# 10 Mb/s Single Twisted Pair Ethernet 10BASE-T1L JAB State Diagram (Comment #469)

Steffen Graber  
Pepperl+Fuchs

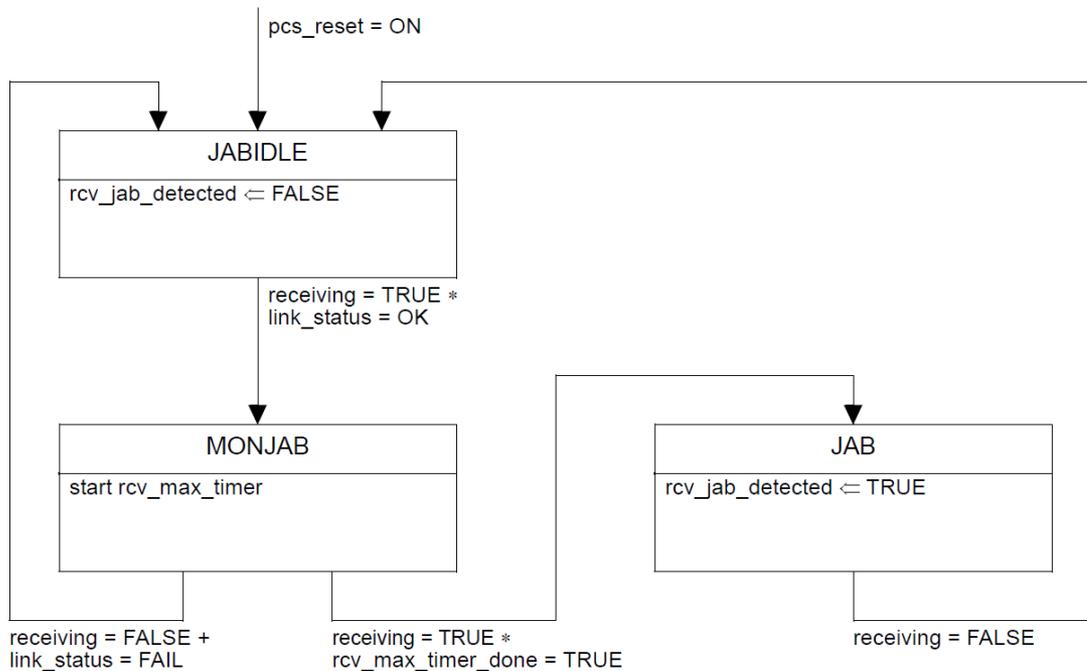
- The Jabber state diagrams of 10BASE-2 (see left side), 10BASE-5 or Clause 147 prevent jabber on the transmit side of a PHY in a multi-drop CSMA/CD environment.
- If a faulty PHY transmits longer than allowed, the output driver of the PHY gets disabled according to the behavior defined in the Jabber state diagram.
- This is completely different to what is described in the JAB state diagram of Clause 146.

- While the Jabber state diagrams of 10BASE-2, 10BASE-5 or Clause 147 prevent jabber on the transmit side of a PHY, the JAB state machine of Clause 146 is needed to reset the receive state machine of a 10BASE-T1L PHY in case an ESD or ESD with error is not received correctly (in this case the “receiving” variable permanently stays TRUE).
- In such a case the receive state machine is brought back to normal operation within 4 ms, as the `rcv_max_timer` of the JAB state diagram has elapsed (which has been agreed by the task force to allow for up to 4 kByte Jumbo frames).
- So suggestion is to keep the JAB state diagram, but to prevent confusion with the Jabber state diagrams in other PHY clauses, to rename the JAB state diagram (and references in Clause 146) to e.g. „Watchdog state diagram“ (which describes better, what the state diagram is doing).
